# Recall Bulletin

## F/CMVSS NONCOMPLIANCE RECALL

**SUBJECT:** Shift Lever Indicator May Not Display Correct Gear

**MODELS:** 2009 Chevrolet Malibu  
 2009 Pontiac G6  
 2009 Saturn AURA  
 Equipped with 4-Speed Transmission (RPO ME7/MN5)

- (1) Shift Cable Locking Tabs
- (2) Shift Cable Adjuster Locking Clip

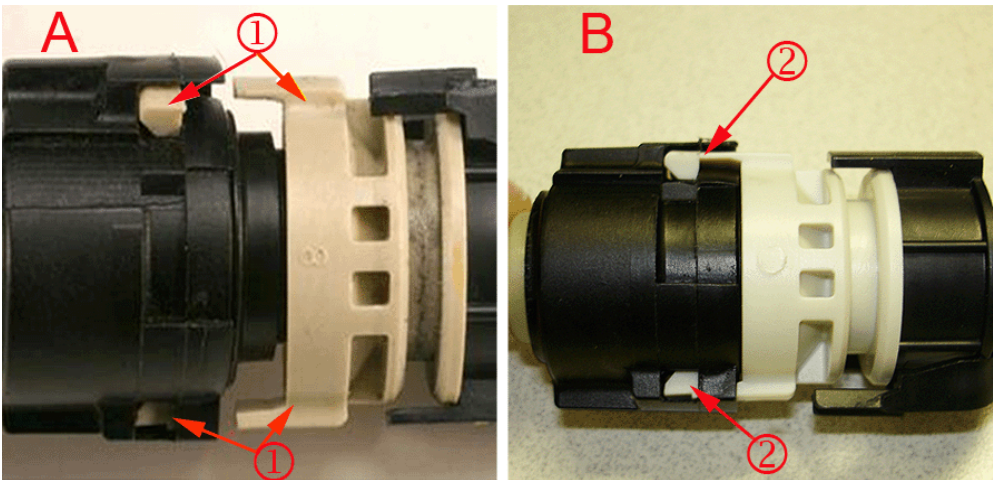
1. Open the hood and locate the transmission shift cable.
2. Determine if the transmission shift cable locking tabs are fractured and separated.

- If the transmission shift cable locking tabs (1) are fractured and separated (A), remove the transmission shift cable and replace it with a new one. Refer to *Floor Shift Control Cable Replacement* or *Range Selector Lever Cable Replacement* in SI. No further action is required after replacing the transmission shift cable. DO NOT install a transmission shift cable kit.
- If the transmission shift cable locking tabs (2) are NOT fractured and separated (B), install the transmission shift cable kit. Proceed to Step 3.

- (1) Clam Shell in Two Pieces
- (2) Clam Shell Around Shift Cable Locking Tabs
- (3) Clamp on Clam Shell
- (4) Inlet Coolant Hose and
- (5) Heater Cooler Pump.

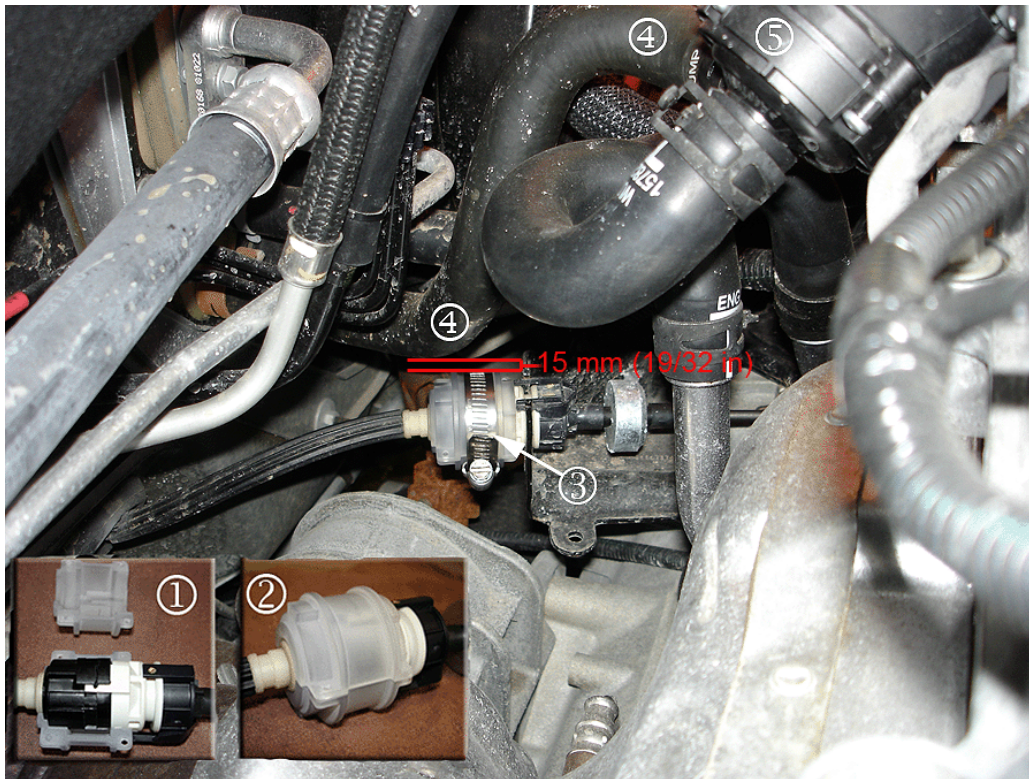
3. Install the clam shell (1) (2) over the shifter cable locking tabs.
4. Install the service clamp over the clam shell (3). Position the clamp fastener head away from the inlet coolant hose (4). **Tighten the clamp to 4 Nm (35 lb-in).**
5. Ensure that there is 15 mm (19/32 in) of clearance between the inlet coolant hose (4) and the clam shell (3). On hybrid equipped vehicles, it may be necessary to reposition the inlet coolant hose (4) to achieve the required 15 mm (19/32 in) of clearance. **To reposition the inlet coolant hose (4) on hybrid equipped vehicles, locate the heater cooler pump (5) and perform Steps 5.1-5.4.**

**Caution:** Do not kink or damage the inlet coolant hose (4) when repositioning the hose to obtain the 15 mm (19/32 in) clearance. To avoid damaging the hose clamp, use J-38185 or equivalent hose clamp pliers to loosen the hose clamp.

- 5.1. Using J-38185 or equivalent hose clamp pliers, loosen the inlet coolant hose (4) connected to the heater cooler pump (5). Note the location of the clamp on the inlet coolant hose (4).
- 5.2. Rotate the inlet coolant hose (4) clockwise until 15 mm (19/32 in) of clearance between the inlet coolant hose (4) and clam shell (3) is achieved.
- 5.3. Ensure that the inlet coolant hose clamp is secure on the inlet coolant hose (4) in the production location.
- 5.4. Install the generator control module cover. Refer to *Generator Control Module Cover Replacement* in SI.
